## Appendix 2.2 – Scoping Responses Received

**Case Reference:**  
**ABP-308291-20**

### **Notice of Pre-Application Consultation Opinion**

**Proposed Development: 564 no. residential units (96 no. houses, 468 no. apartments), childcare facility and associated site works.**

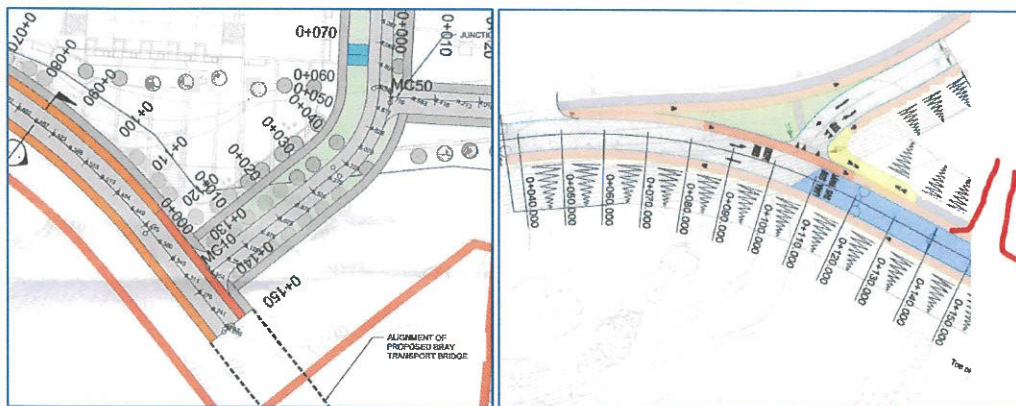
- CYC1. The termination of the cycle paths at all of the vehicular entrances/access points to the proposed development should be designed in accordance with the National Cycle Manual.

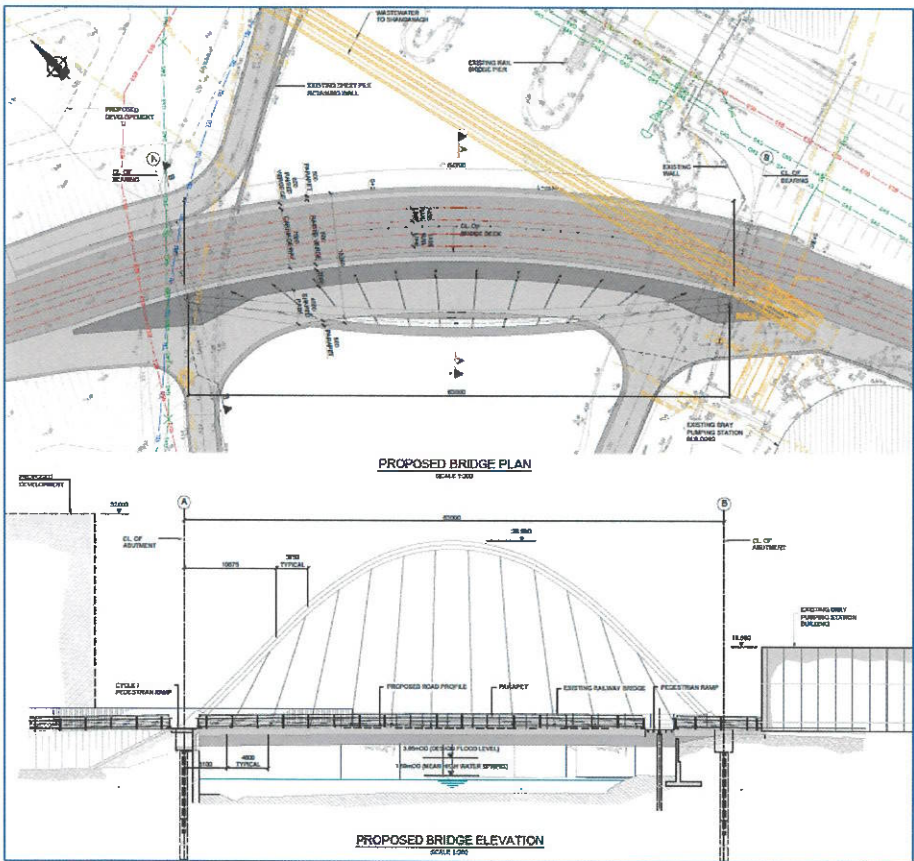
- O2. It is noted that the applicant in the masterplan has shown the LUAS alignment on the north of the existing road serving the rail underpass while Wicklow Co Co in its development of the bridge shows the LUAS alignment on the south side of the road.

Wicklow Co Co undertook a design based on the original planning to fix the position of the bridge structure. We have currently shown this feasible alignment on our Part 8 documents to demonstrate that the LUAS can be accommodated and is shown for illustrative purposes only (planning is not been sought for the LUAS Alignment). If the applicant proposes to change the alignment of the LUAS it should be done in such a manner as not to affect the viability and use of the proposed public transport bridge.
